PRELIMINARY/FINAL DRAINAGE REPORT

**MIDTOWN COLLECTION AT HANNAH RIDGE
FILING No. 3**

PUDSP-20-007

Engineering Review

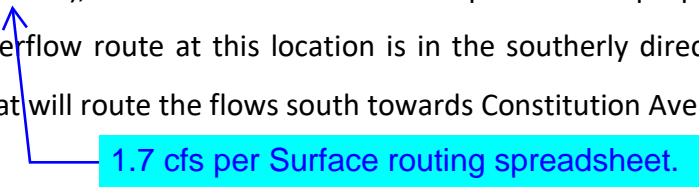
B-1?

DEVELOPED
Drainage Map

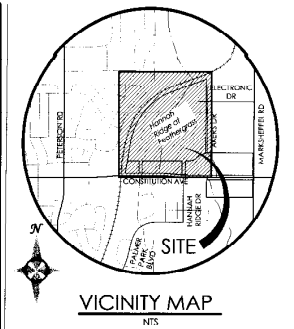
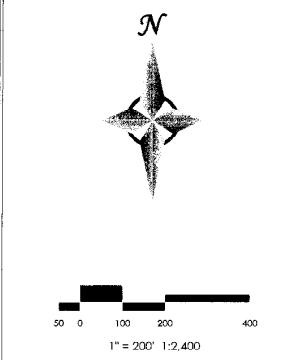
Include copies of calculation sheets that accompanied this map from previous report.

Project: Midtown Collection at Hannah Ridge Filing No. 3
 Inlet ID: DP #3

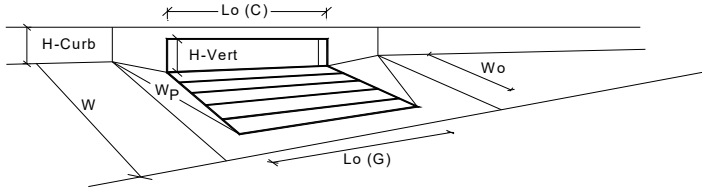
Grading shows street as crowned section, distance to crown of road can't be greater than 15', please update width accordingly.

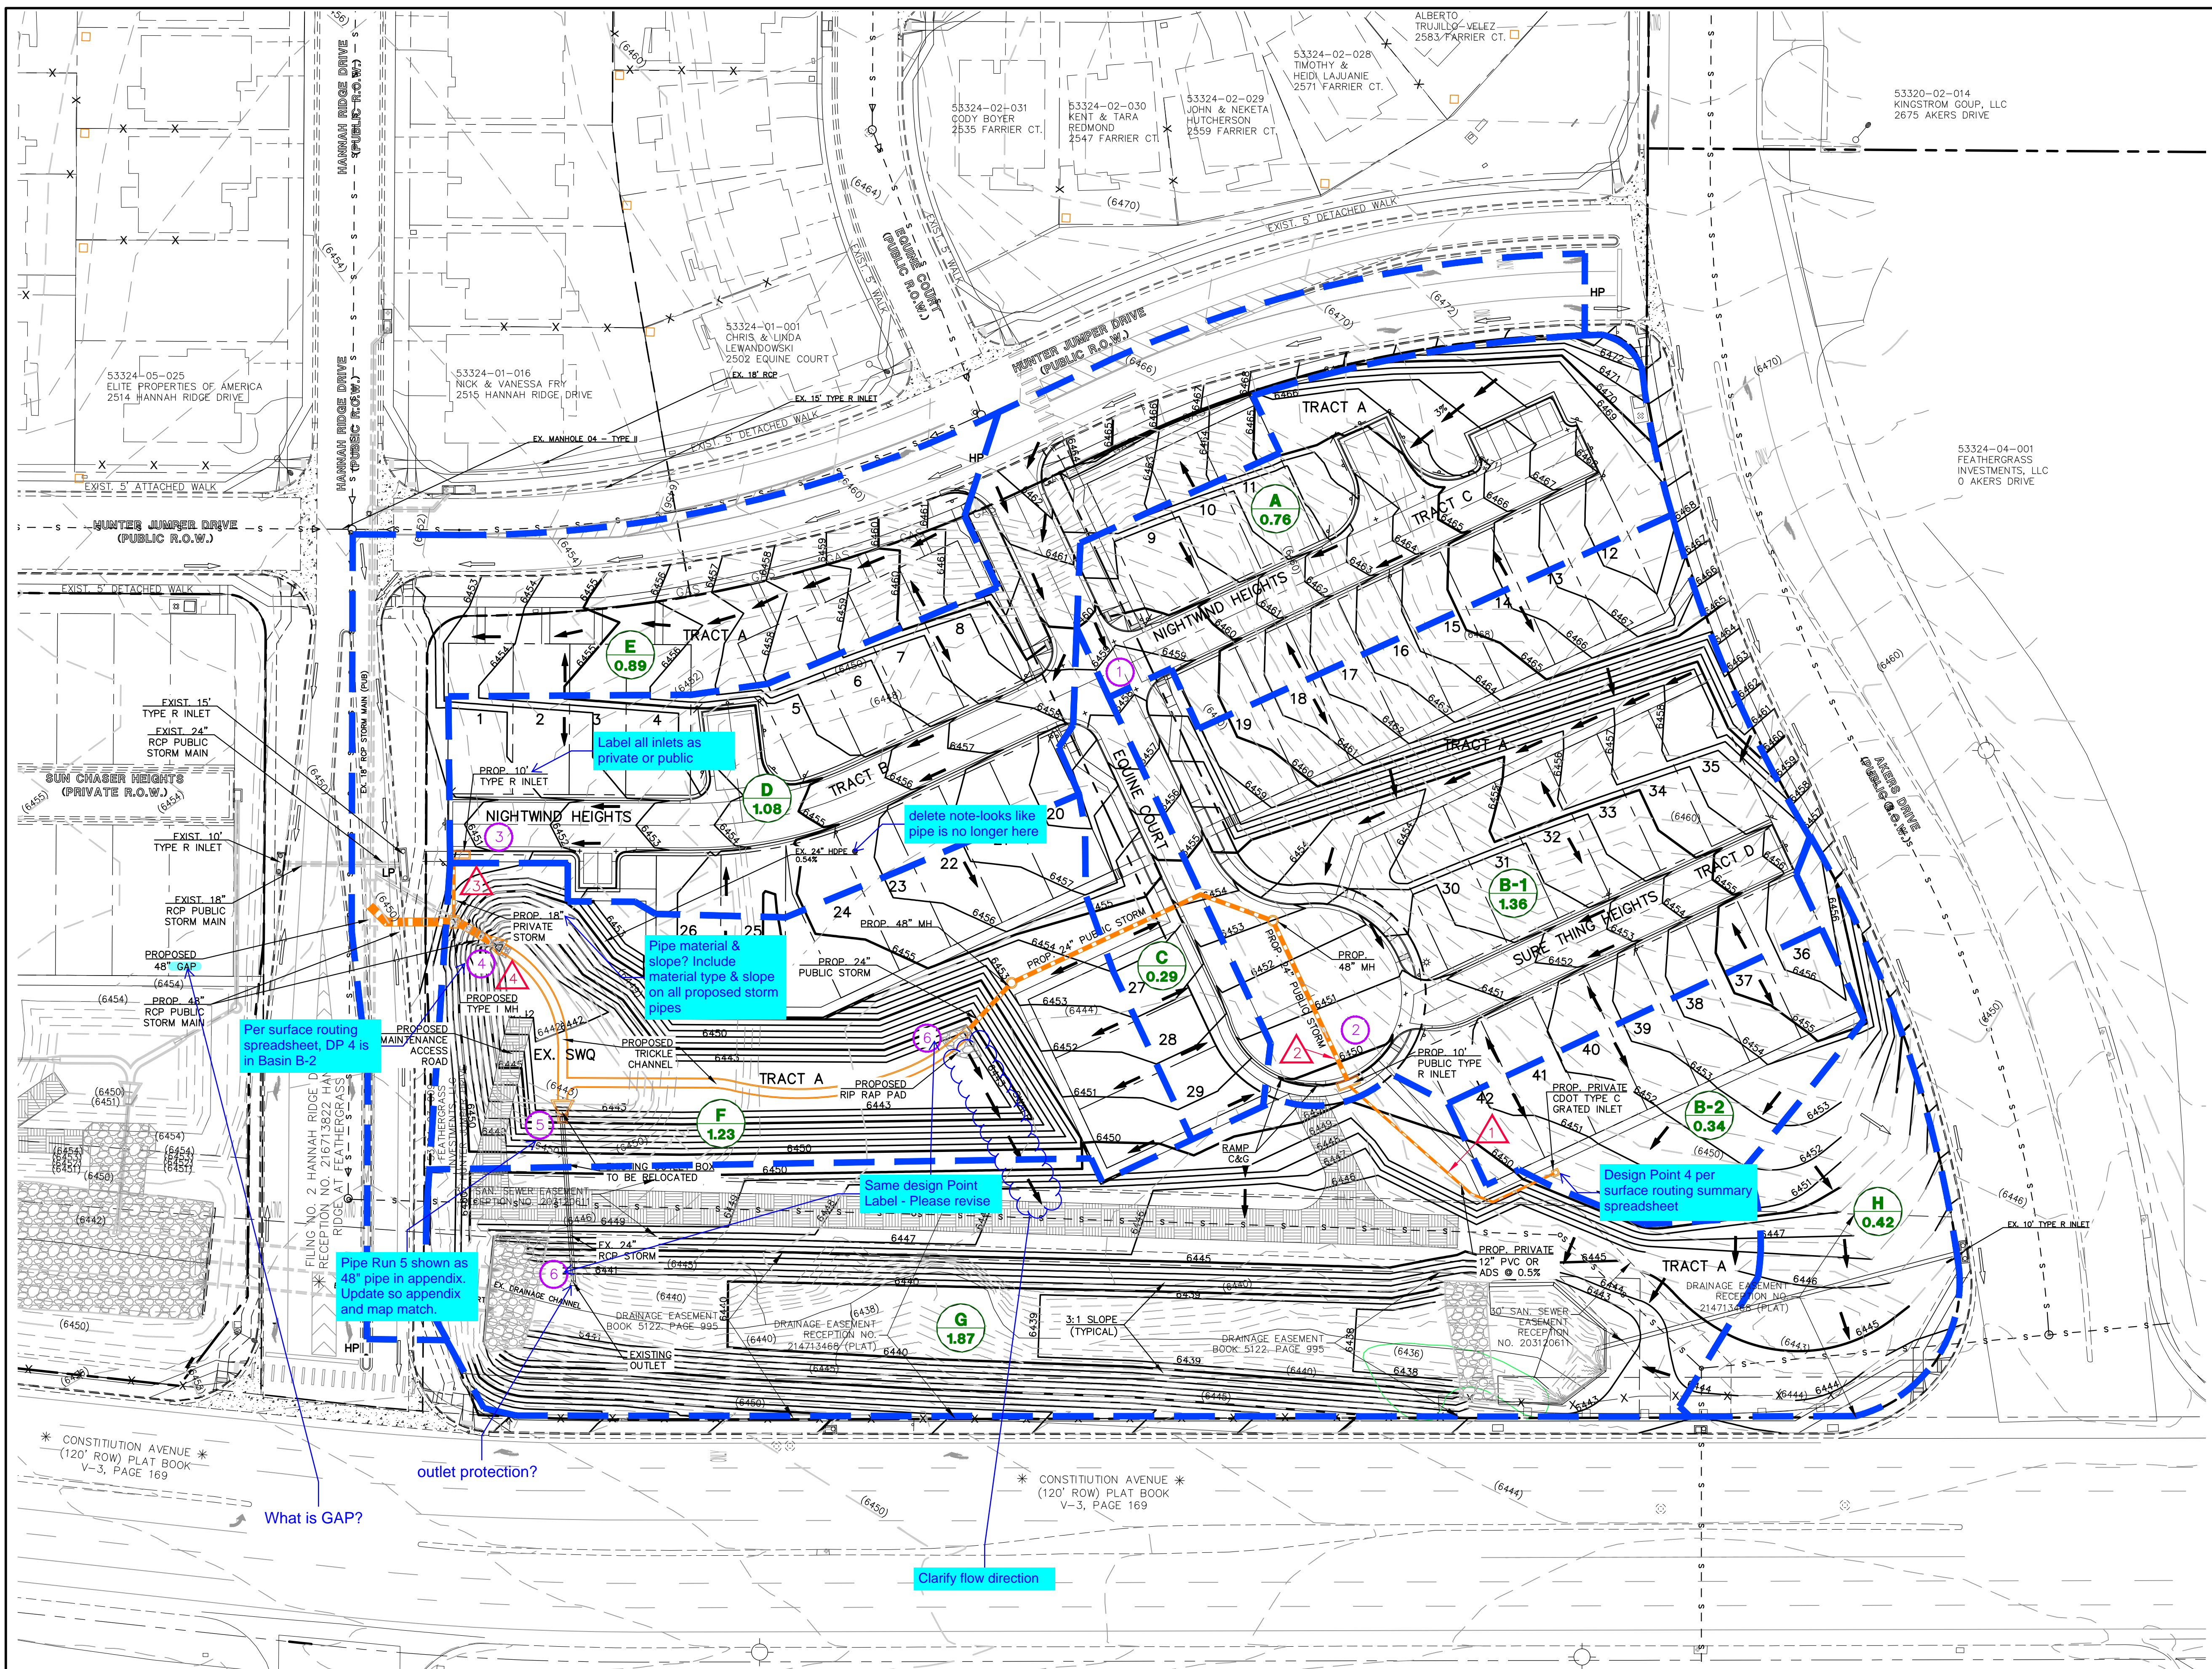
On drainage map Pipe Run 5 is outlet culvert for pond which is 24" pipe. Please update to whichever is correct location/structure for Pipe Run 5.

Provide Existing or overall Drainage Plan showing the entire drainage area to the FSD. This can be combined with the MS4 map requested in the comments.
